Reconstruction to  
Plattekill Elementary School

Tt Project No. 17597-22002 – Phase 2B

BID Addendum No. 1  
to  
Drawings and Project Manual

October 21, 2024

DP01B

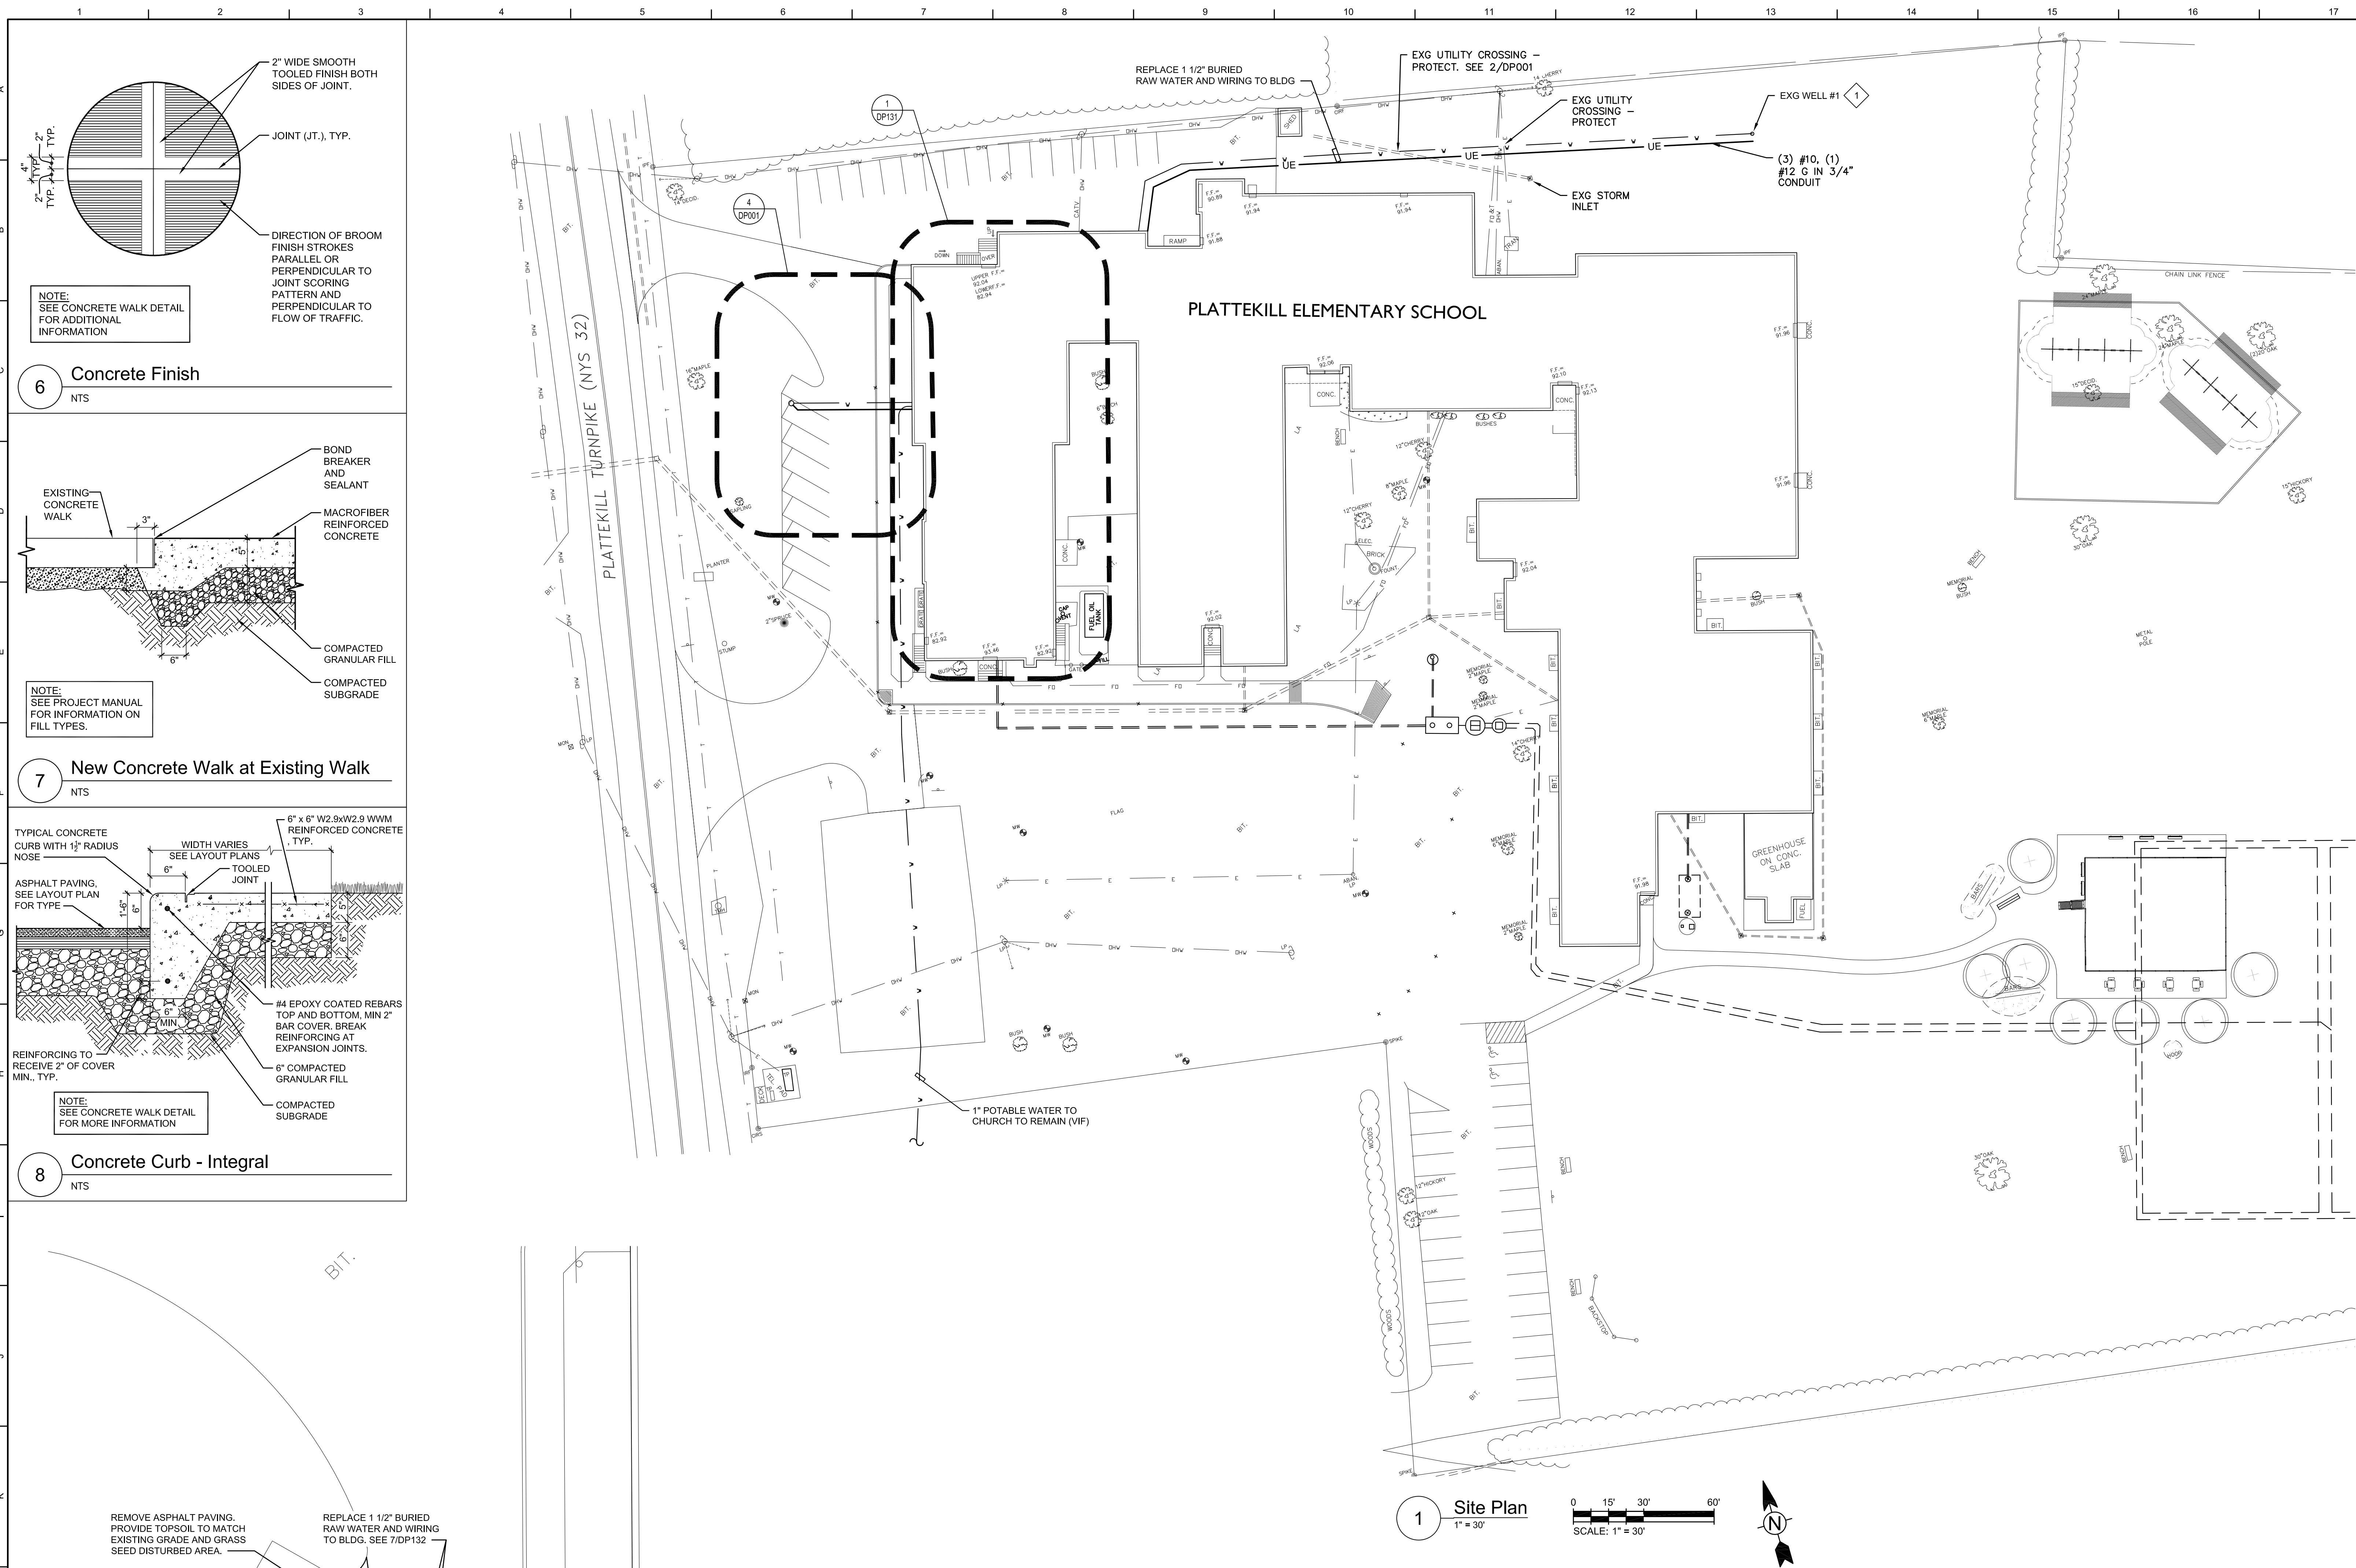
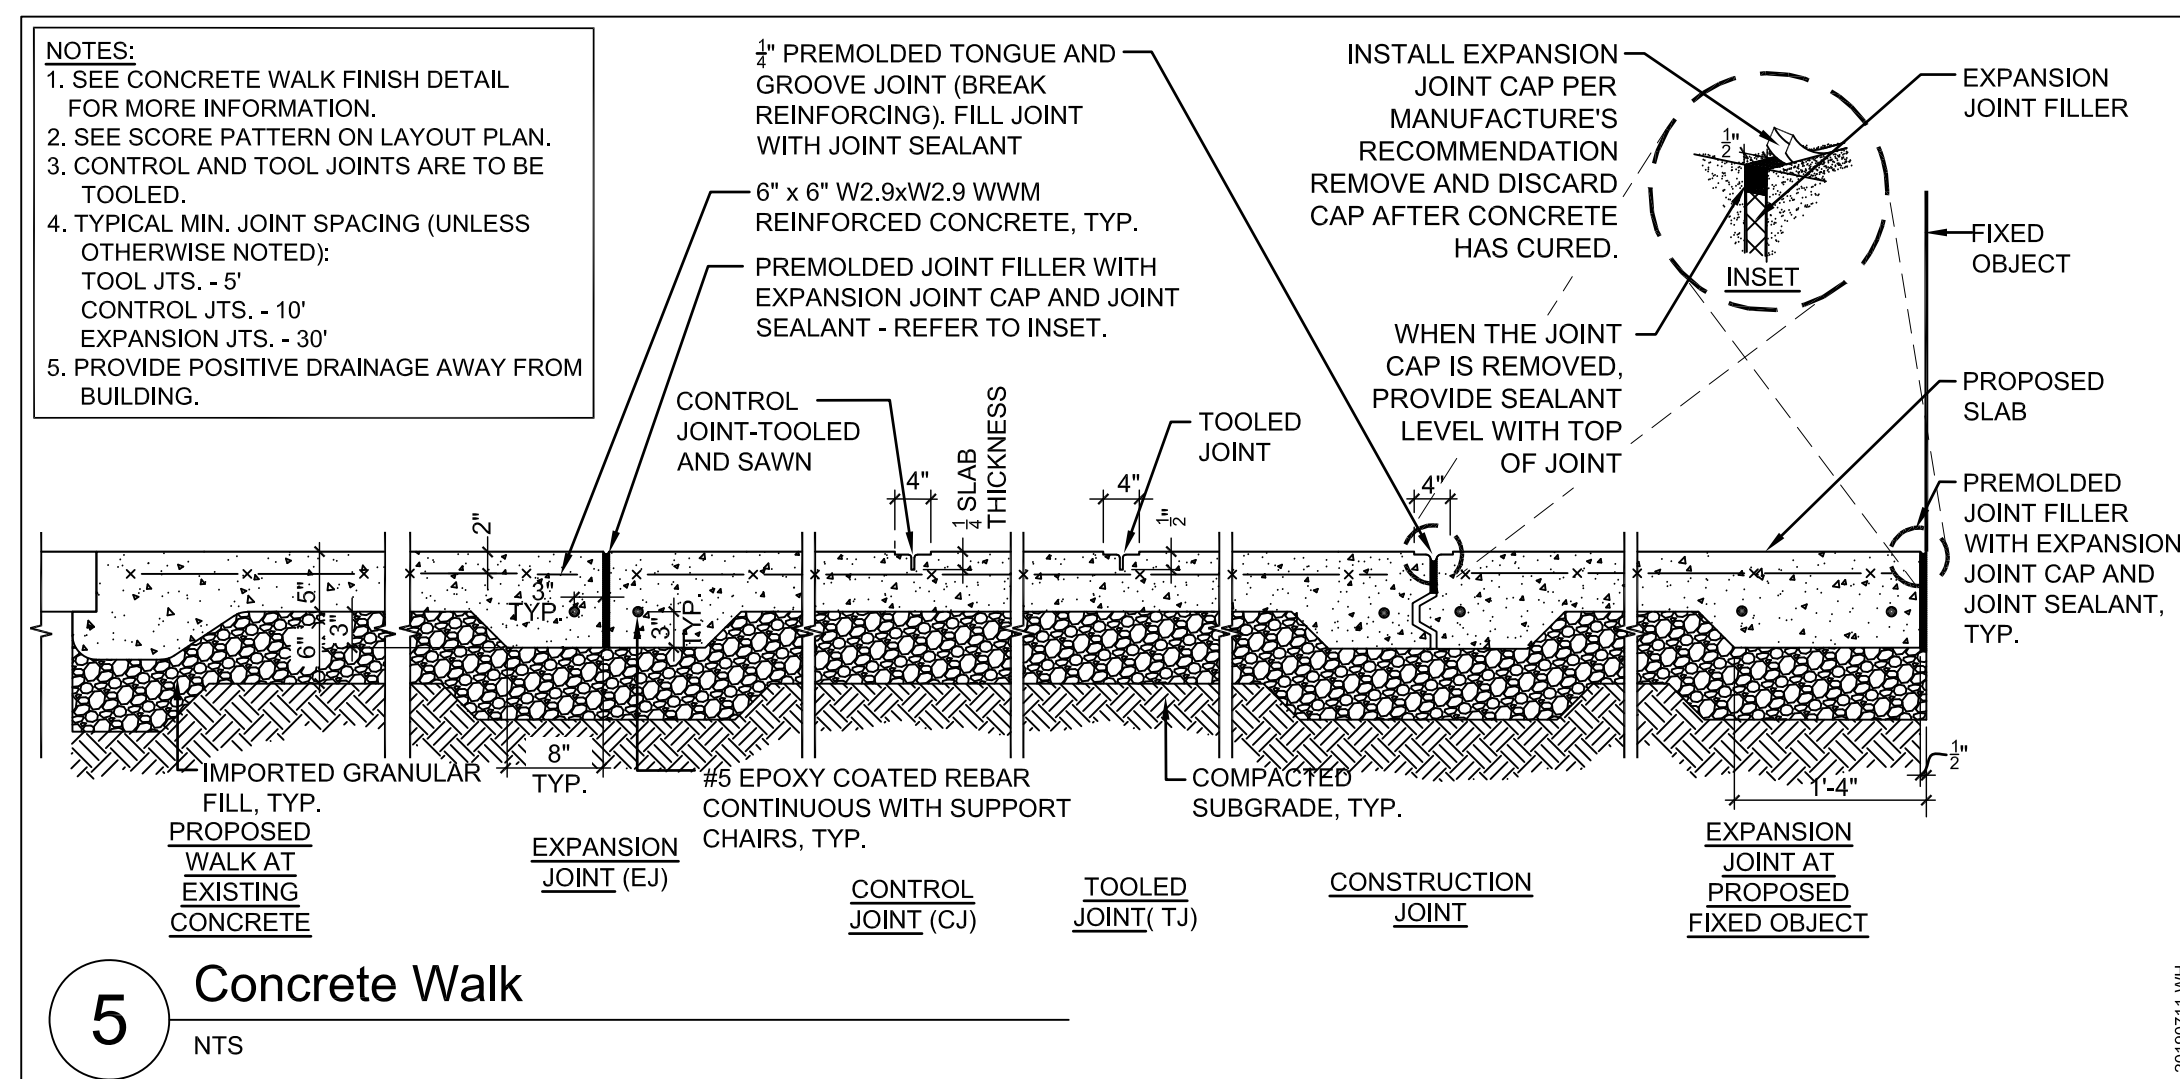
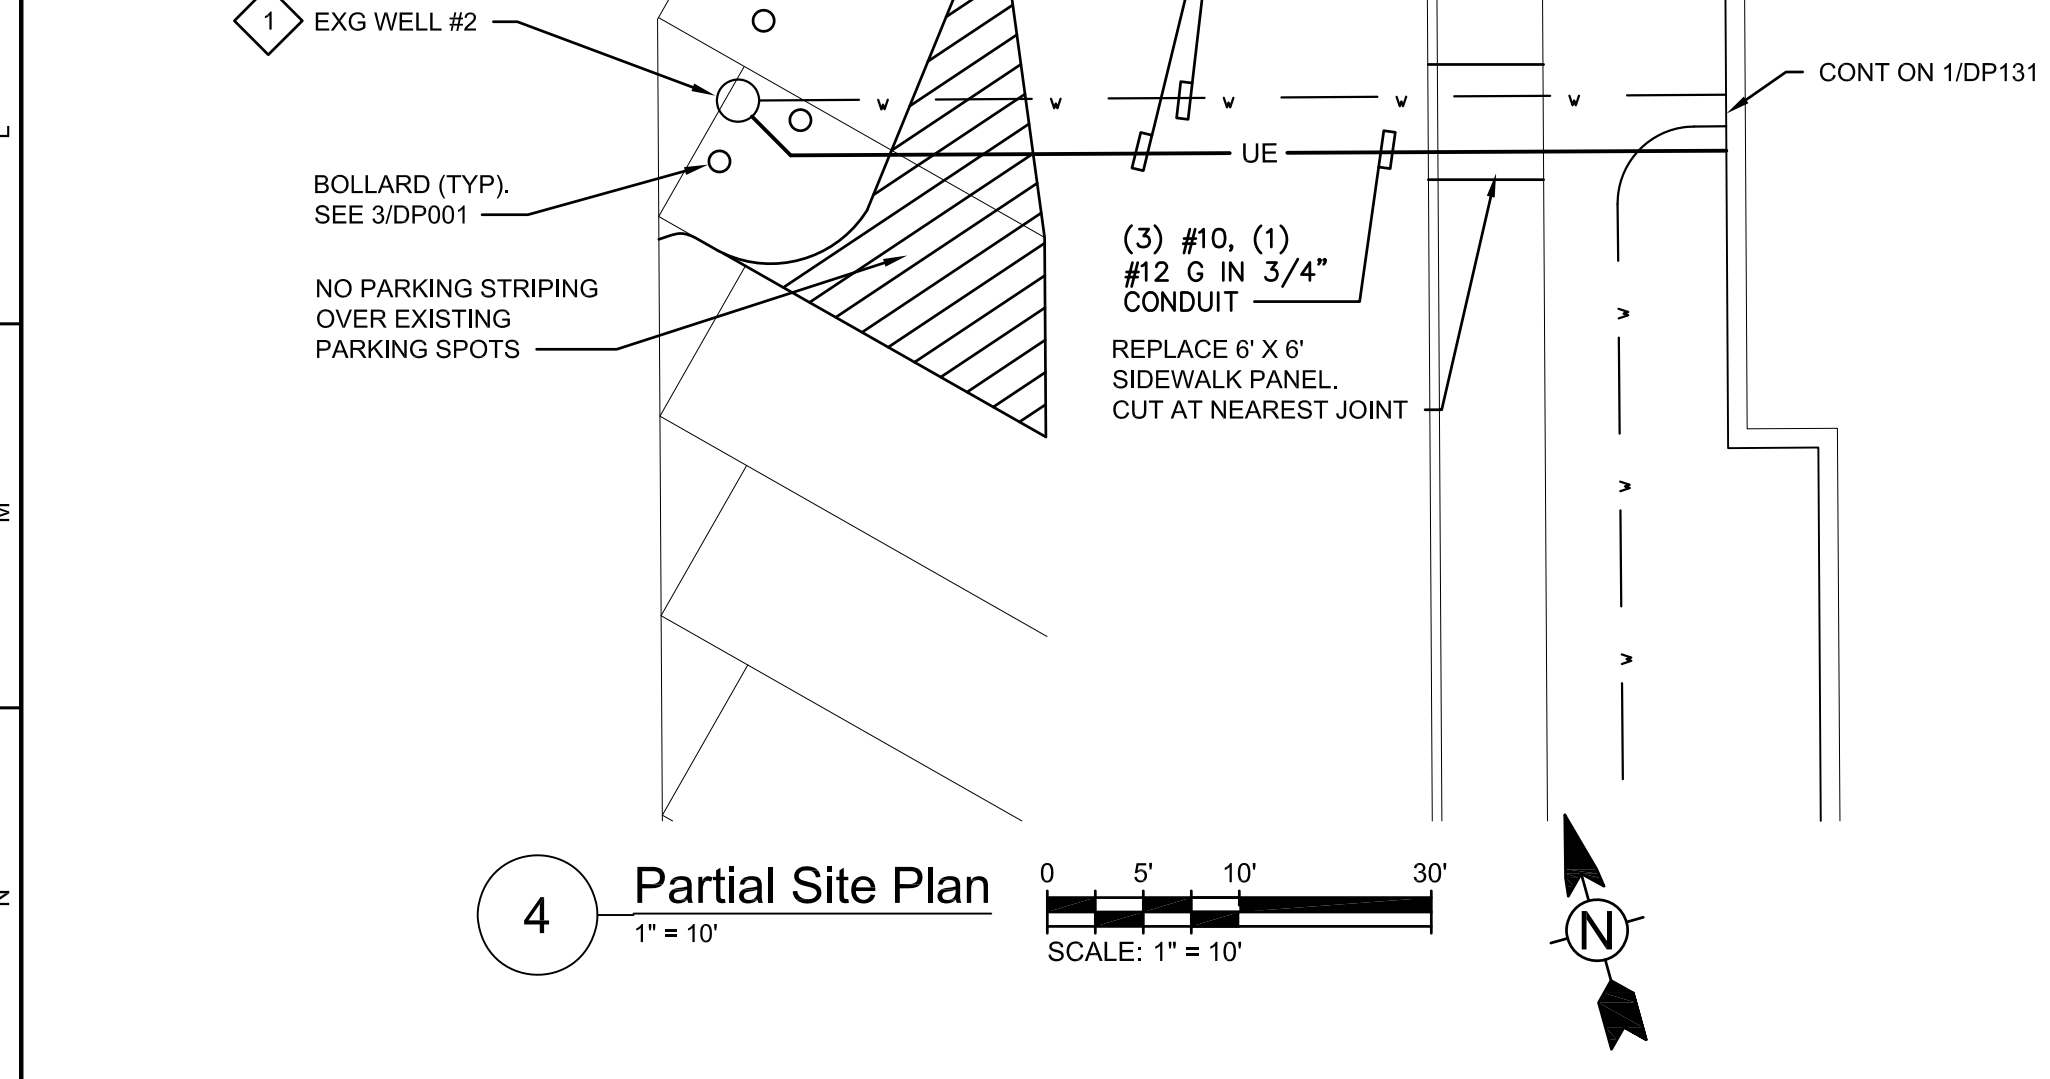
1. Detail 3, AMEND as shown on Drawing DP01B attached to this addendum.
